# Access Compliance Report

## Public Rights-of-Way

### (Curb Ramps)

Intersection ID: 13007	Main Street: HAWTHORNE_LN	Cross Street: CENTRAL_AV	Location:	SE
ADA ID: C3F96C556CC6	Ramp Type: PerpDiag	Initial Pass/Fail: Fail	Overall Compliance: No	Severity Score: 22.5
Codes/Mitigation Info/Possible Solution		Field Measurements/Component Compliance

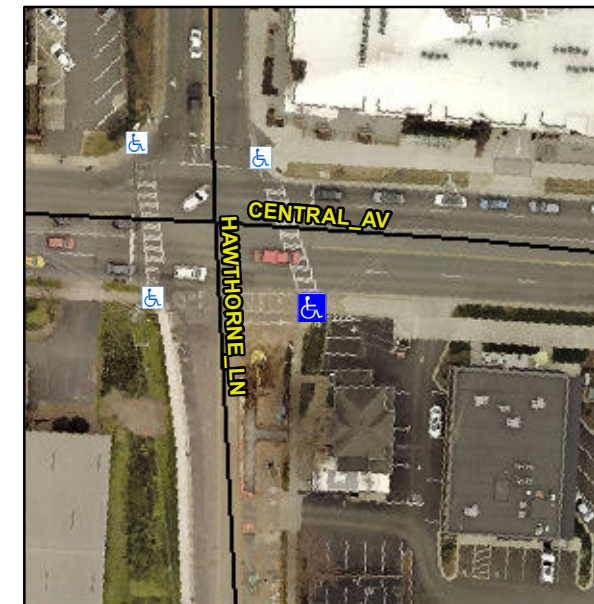
**Not Found, R304.5.1, R304.2.2, R304.5.3**

Compliance	Description	Data	Compliance	Description	Data
N/A	Ramp Length (in)	58.5	No	Ramp Slope (%)	9.7
No	Ramp Width (in)	43.0	No	Ramp XSlope (%)	4.2
N/A	Flare Type LT	N/A	N/A	Flare Type RT	N/A
N/A	Flare Slope LT (%)	N/A	N/A	Flare Slope RT (%)	N/A
N/A	Flare Traversable LT?	N/A	N/A	Flare Traversable RT?	N/A
N/A	Landing Length (in)	N/A	N/A	DWS Provided?	N/A
N/A	Landing Width (in)	N/A	N/A	DWS Contrast?	N/A
N/A	Landing Slope (%)	N/A	N/A	DWS Length (in)	N/A
N/A	Landing X Slope (%)	N/A	N/A	DWS Full Width?	N/A
N/A	Landing Curb? (Y/N)	N/A	N/A	DWS Offset (in)	N/A
N/A	Shared Landing?	N/A			
N/A	Gutter Ponding?	N/A	N/A	Gutter Slope (%)	N/A
N/A	Gutter Lip Ht (in)	N/A	N/A	Gutter X Slope (%)	N/A
N/A	Painted X Walk1?	Yes	N/A	Painted X Walk2?	Yes
	X Walk 1 Direction	To N		X Walk 2 Direction	To W
N/A	X Walk 1 Width (in)	109.0	N/A	X Walk 2 Width (in)	105.0
	X Walk 1 Slope (%)	3.8		X Walk 2 Slope (%)	2.5
	X Walk 1 X Slope (%)	4.4		X Walk 2 X Slope (%)	0.1

N/A	Ramp inside XWalk1?	Yes	N/A	Ramp inside XWalk2?	Yes
	Road Slope (%)	2.8	N/A	Clear Space?	N/A
	Road X Slope (%)	4.2	N/A	Clear Space to XWalk (in)	N/A
N/A	Any Obstructions?	N/A	N/A	Storm Grate/Utility Hazard?	N/A
	Obstruction Type			Storm Grate/Utility Type	
		N/A			N/A
		Yes		Surface Condition? (G/P)	Good

**Remove & Replace Curb Ramp With Two New Directional Ramps or Equivalent.**
